RE: RESPONSE TO JOE CLARK - NEIGHBOR ON 14298 LORA DRIVE

RE: RESPONSE TO HOOMAN BOLANDI - NEIGHBOR ON 14333 MULBERRY DR.

THE A. CHAUBE RESIDENCE, 14300 Lora Drive, Los Gatos, CA 95032

MR H BOOLANDI'S CONCERNS ADDRESSED

DESIGN REVISION & IMPROVEMENT

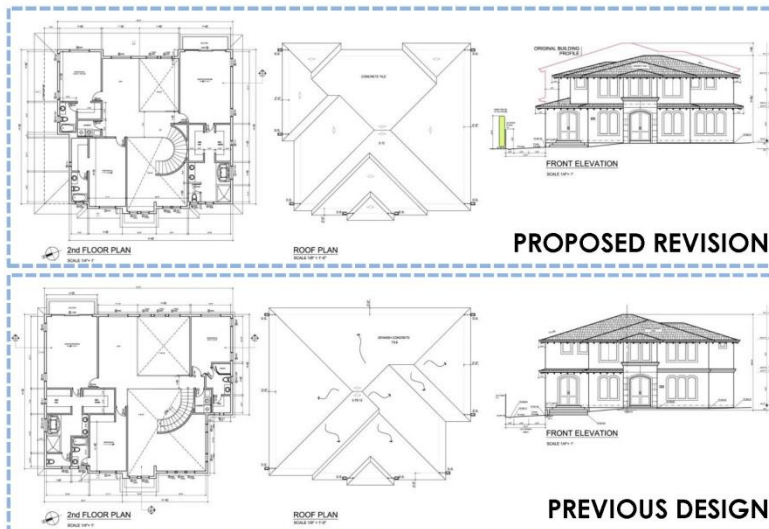
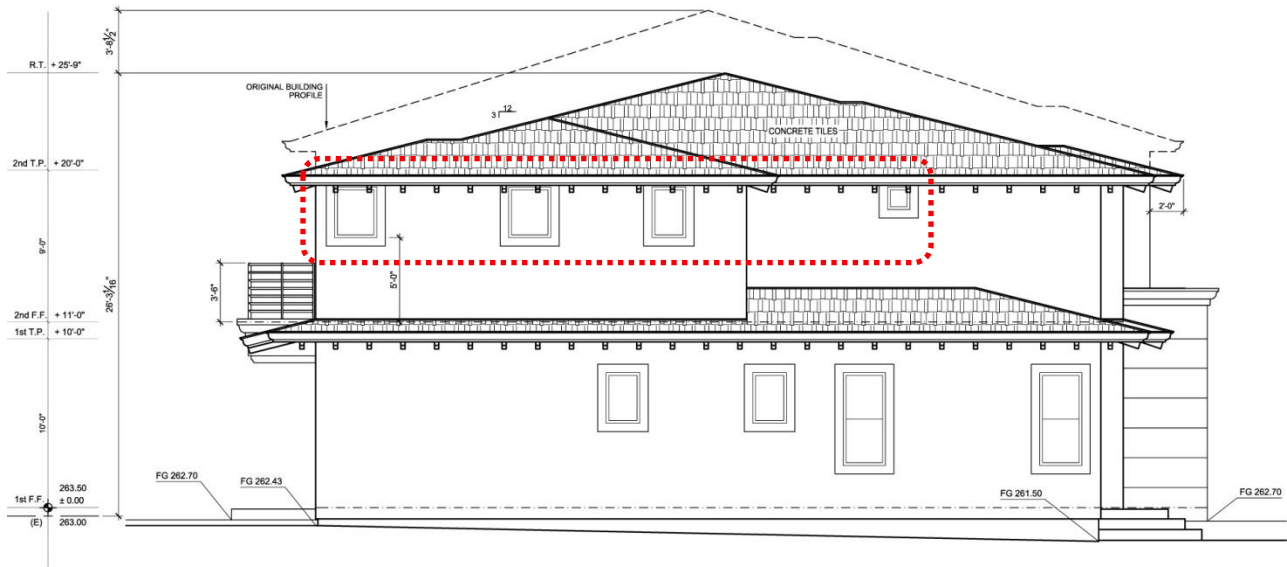
1. The overall height of the house has been reduced by 3'-8.5", a few inches short of 4 ft. as you requested. **Agreed - Thank you.**
 - a. The foundation is 2 ft lower as you had suggested as well. **Agreed - Thank you. Finished Floor Height installed at 263.5 - w/ survey elevation confirmation.**

- b. Additional step back, as requested, has been introduced, 7'-6.5" towards the front of the house closer to your home, and 4 ft. towards the backyard. **Agreed. Thank you. If further chances in size are necessary, we would prefer this wall to be brought to 7'-6.5" across the entire side.**

- c. An additional roof therefore has been introduced similar to a non-formal architectural style as per your suggestion. **Agreed. Thank you. I am assuming this is in reference to the roof under the step backs.**

- d. The pitch of the roof has been reduced as you had suggested, to allow for more sun to come into your background. The Solar impact is now minimal due to reduced height. **Agreed. Thank you. Based on the provided solar study, this seems like a good compromise.**

- The overall height has been reduced by 3'-8.5" by lowering the foundation and roof.
- Left side of L2 is setback by 4' to provide privacy and visual relief to the left neighbor (14298 Lora Dr.).
- The second floor has been reoriented to provide additional privacy to the left neighbor.
- Balcony has been positioned to the right side, increasing the distance from the left neighbor.
- Voids has been reduced by 254sf.
- All around roof between the 1st and 2nd floor has been introduced to accommodate neighbors concern about the solid wall as well as privacy concern.
- Portion of 2nd floor rear elevation is setback around the void and loft area to break the continuous wall and to further reduce roof height.

MASS, BULK, SCALE COMPARISON

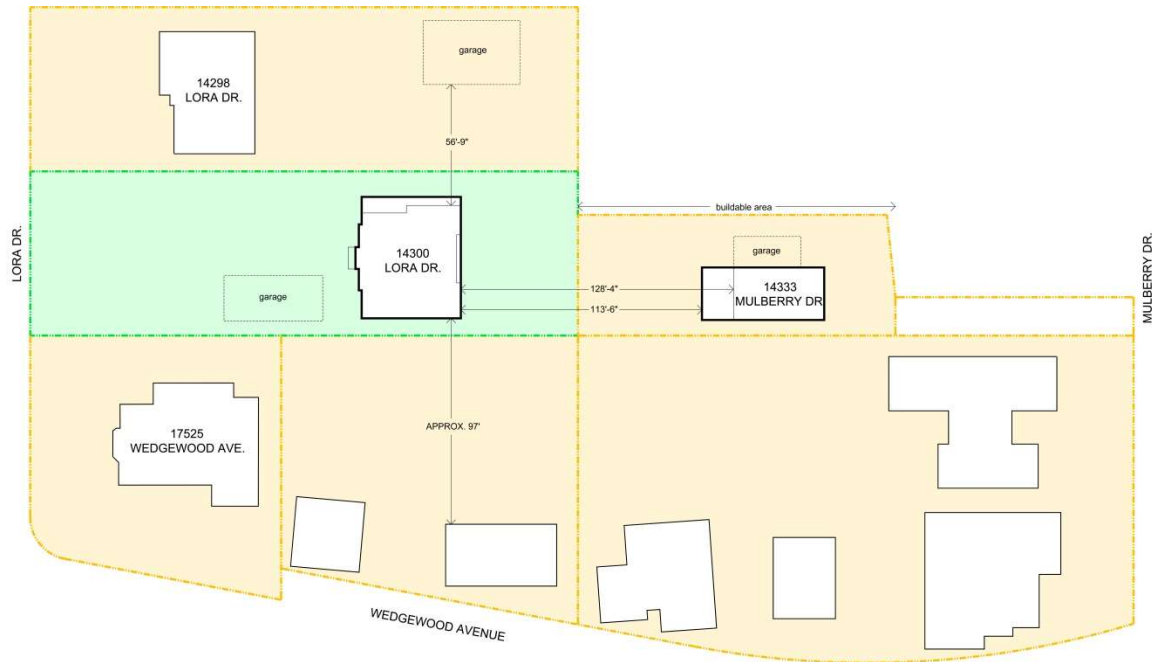
While my family & I appreciate your effort on reducing the proposed height by 3 ft 8 inches and introducing a setback of 4 ft on one side, unfortunately, the overall mass (width of the 2nd floor) and height of structure is still towering over our property. Looking at the 2nd floor floor plan layout, there is plenty of "void" space (~800 sqft) that allows for more mass (width) reduction which results in further reduction of overall height.

Our Ask is to please reduce the overall mass (width) of the 2nd floor proposed structure. This will further reduce the overall height.

- **Overall** the height of 14300 Lora Dr is now **7'55"** lower than 14333 Mulberry Dr
- 14333 Lora Dr. has been lowered to be **5' 36"** below Mulberry Dr. **first floor**
- Second floor height has **been lowered to be 5'5"** below mulberry drive **2nd floor height**

PRIVACY

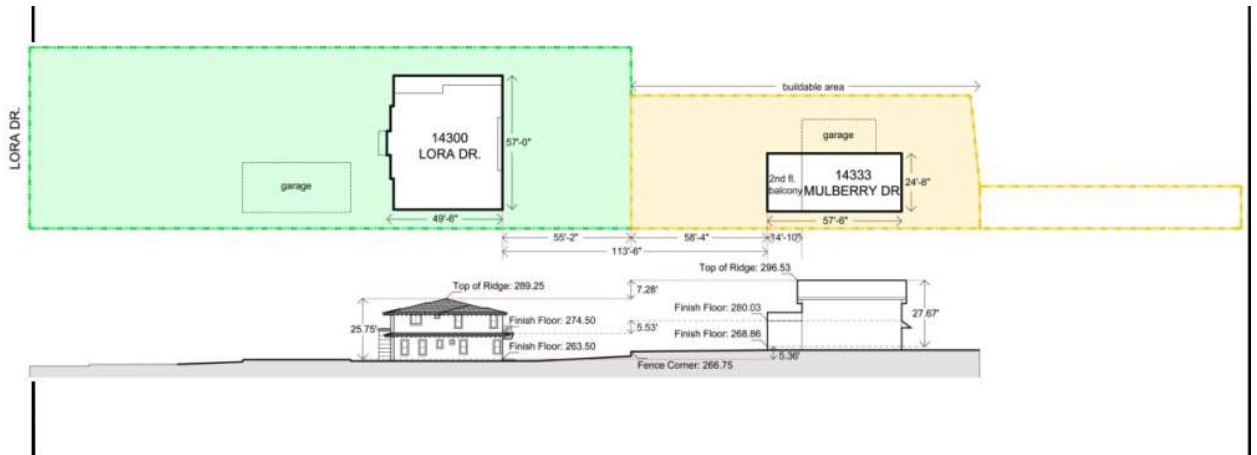
Unfortunately, planting trees by the fence of Mulberry dr. will diminish the value and effort of reduced overall height of 3ft 8 inches. The trees should be planted against your proposed house and they can be in a staggered pattern to create a shaded patio area for your backyard. This will be a Win-Win for both of our families.

Our Ask is to please plant trees against your proposed house, reduce the overall mass (width) of the 2nd floor proposed structure, install privacy screen lattice on the fence and around balcony

- Several existing trees already provide privacy
- Rails on the balcony to provide privacy as requested.

- 14333 Lora Dr. has been lowered to be 5' 36" below Mulberry Dr. first floor
- First Floor privacy will be provided through additional lattice on the fence till 8 ft.
- Second floor height has been lowered to be 5'5" below mulberry drive 2nd floor height
- Distance including the setbacks between the second floors of the two houses is a total 123' 6"
- Additional Screen trees will be added to provide additional privacy. Screen trees will be added 5ft from the property line to minimize shadow. Shadow study has been created to depict minimal impact.

Mass & Scale → Sun Blockage & Shadowing

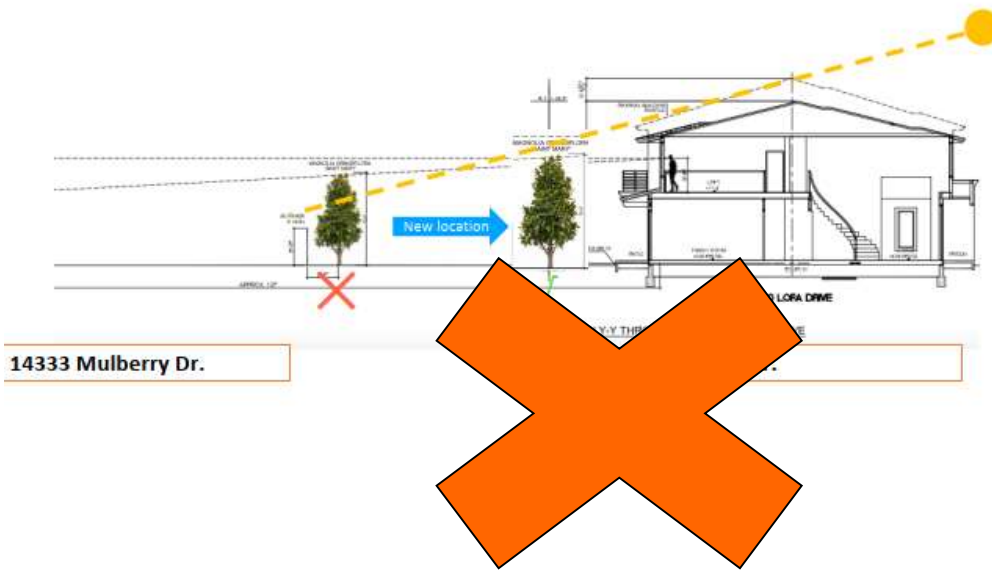
- Clear due to mass and scale of the proposed plan **14333 Mulberry will be impacted.**

This is going to be a problem for my mother who is 85+ years old and is required to get sun.

No shadow on Mulberry

Privacy & Shadow

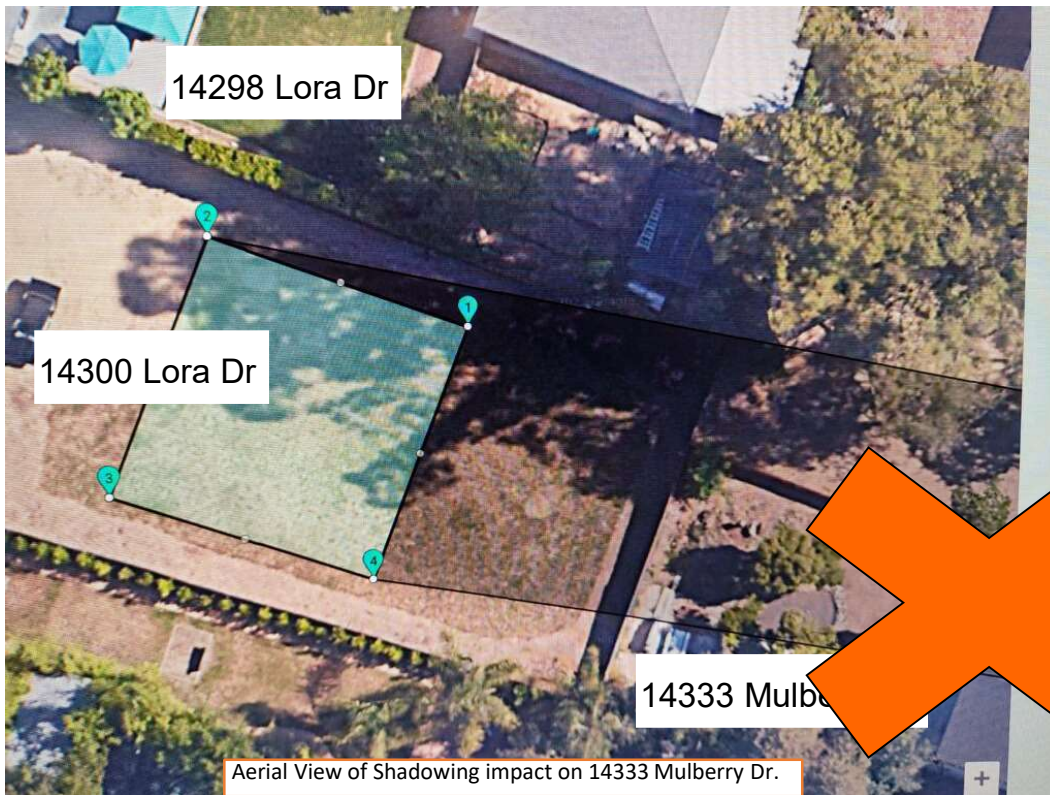
- Planting Trees by the fence of Mulberry dr. will diminish the value of reduced exterior wall height.
- Planting trees by the fence will create Shadow on 14333 Mulberry dr.

The overall massive scale of the proposed house is towering over 14333 Mulberry Dr.

Inaccurate representation –Shadow study provides accurate solar impact

DRAINAGE

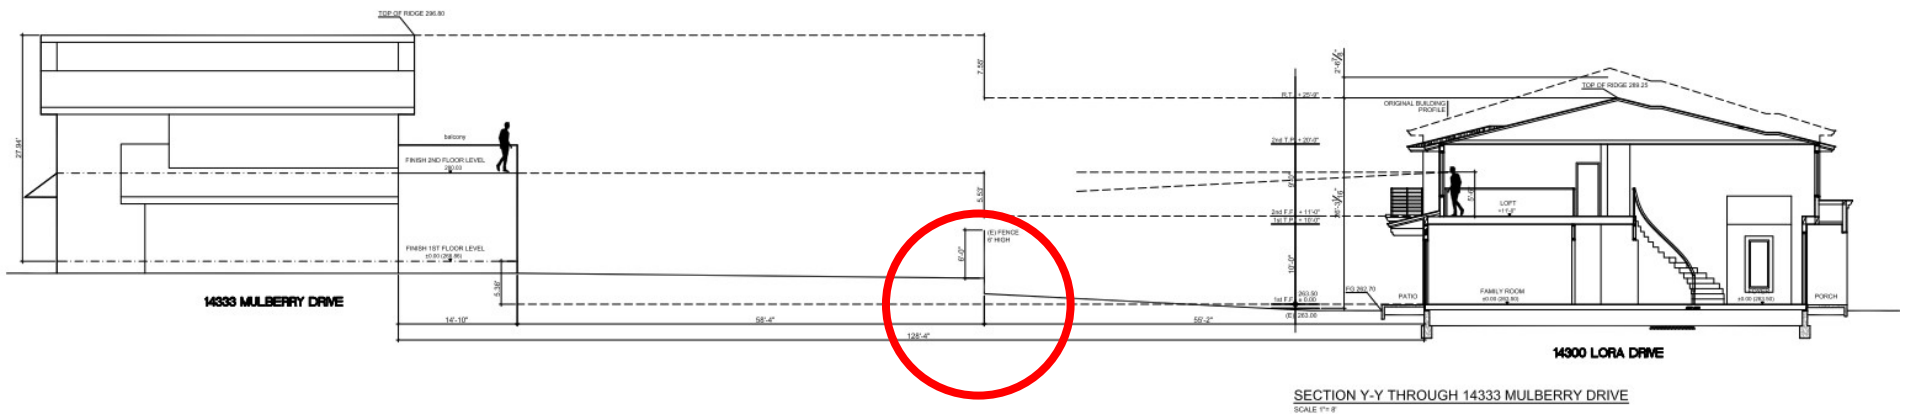
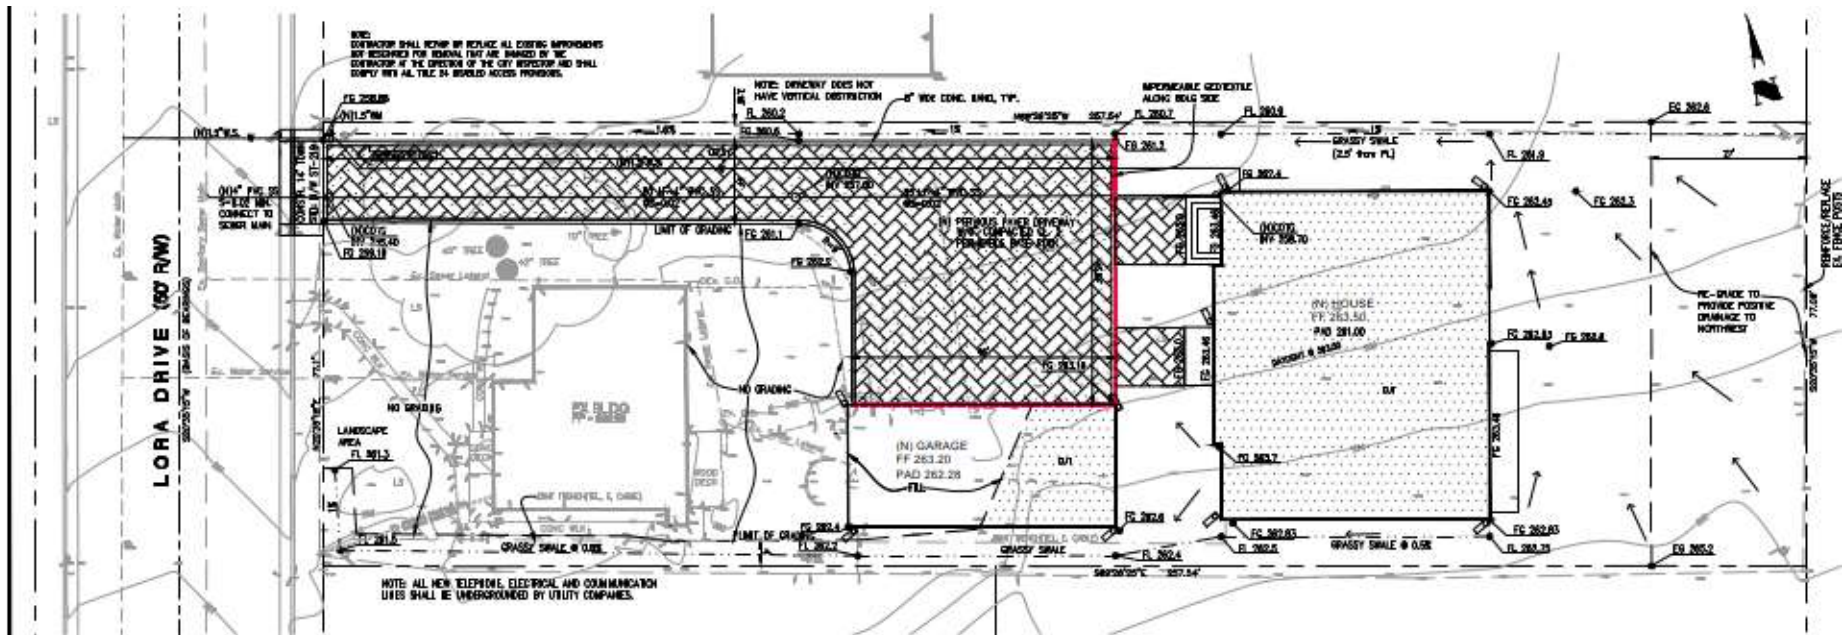
- On the new plan I did not see any note regarding drainage near Mulberry fence ✓
- Re-establish positive drainage. ✓
- Install rain water management system ✓
- Reinforce the fence posts ✓

Positive Drainage plan is part of Civil plan

A: - REVISED C1 GRADING & DRAINAGE IS SHOWING POSITIVE DRAINAGE AND DEFINITELY WATER RUN-OFF PER CODE
- REINFORCE THE FENCE WILL BE DONE AS NECESSARY
